This Service Information bulletin supersedes S.I. 12 10 99 **dated May 1999** which should be removed and discarded from your S.I. binder.

SUBJECT: Voluntary Emissions Recall Campaign No. 99E-A01

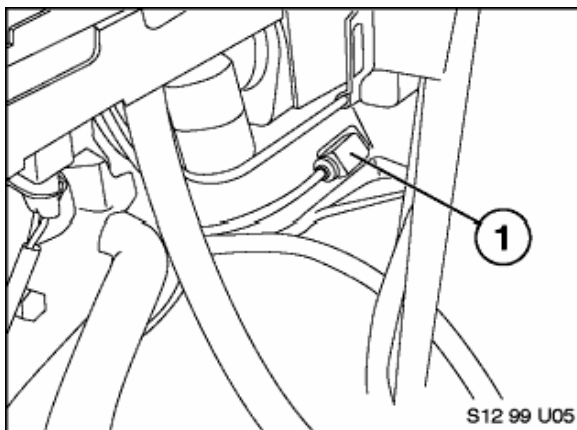
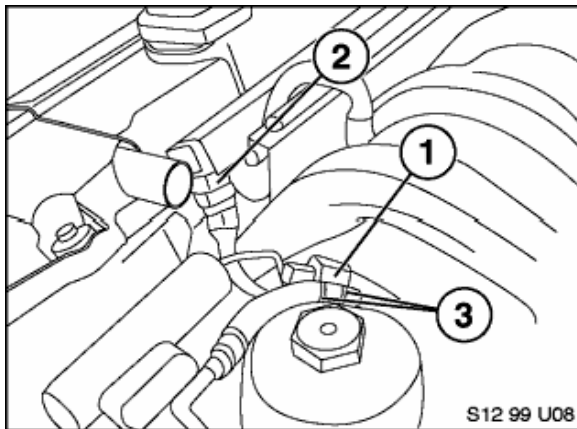
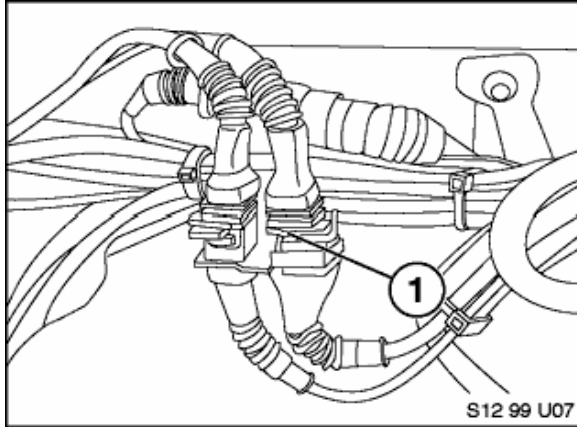
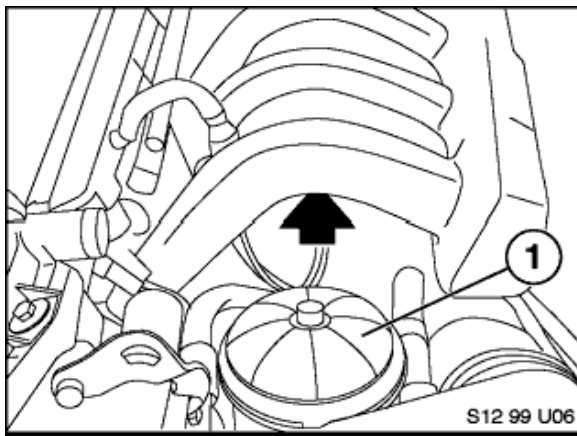
1. Remove the crankshaft position sensor which is located below the starter motor.

Remove the Sensor (1)

If the sensor currently installed in the vehicle has a connector directly on the sensor which can be disconnected, then the new sensor is already installed. No further action is required and the DCS contact can be closed.

The crankshaft position sensor needs to be replaced with the same type of sensor that is currently being used on the M52TU engine. Along with replacing the sensor an adapter harness must also be installed in order to supply the sensor with a 12V operating voltage instead of the 5 volts currently being supplied by the DME.

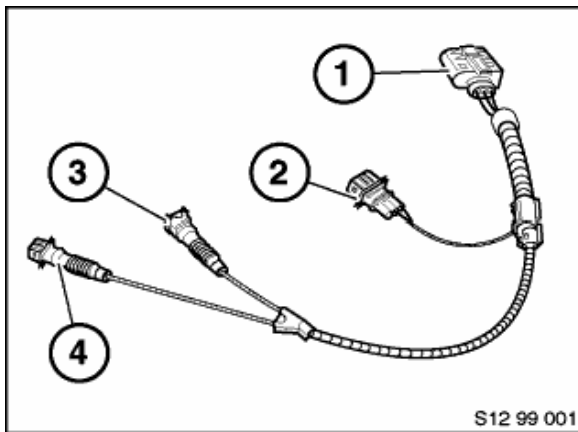
2. The electrical connection of the crankshaft sensor to the engine harness is located below the intake manifold.

To access this connector, the cap of the oil filter housing (should be removed and the oil filter and housing should then be covered to prevent dirt from getting onto the oil filter.

3. Disconnect the crankshaft position sensor (1) from the engine harness.

Note: This illustration shows the plug connectors with the intake manifold removed. **It is not necessary to remove the intake manifold in order to gain access to these connectors and complete this repair.**

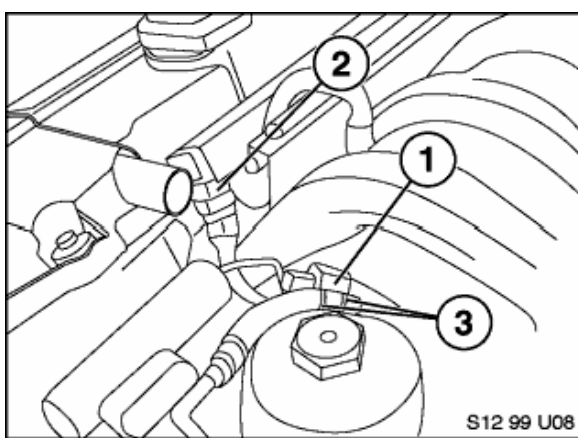
6. Install adapter harness P/N 12 51 4 592 703.
 - a. Connect (1) to the new crankshaft position sensor.
 - b. Connect (2) to the engine harness connector which was previously connected to the old crankshaft sensor located below the intake manifold.
 - c. Connect (3) to the VANOS solenoid valve located on the VANOS unit.
 - d. Connect (4) to the engine wiring harness connector which previously connected directly to the VANOS solenoid valve.

5. Install the new crankshaft position sensor (1) P/N 12 14 1 709 616 and O-ring P/N 12 14 1 748 398.

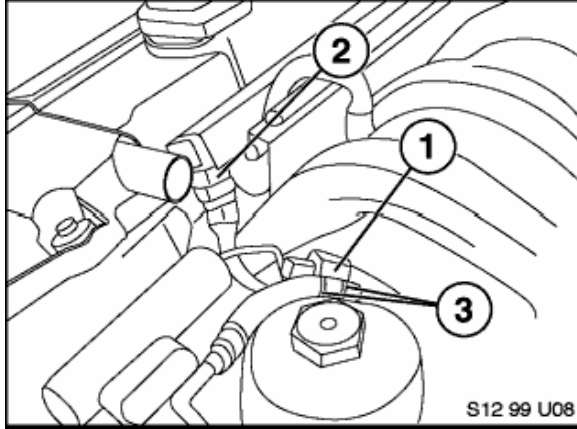
7. After the adapter harness has been installed secure the harness lead going to the VANOS solenoid valve (1) to the VANOS oil line with 2 cable ties (3).
- Note: The harness lead going to the VANOS solenoid valve should not be under tension. The harness lead should be able to move.
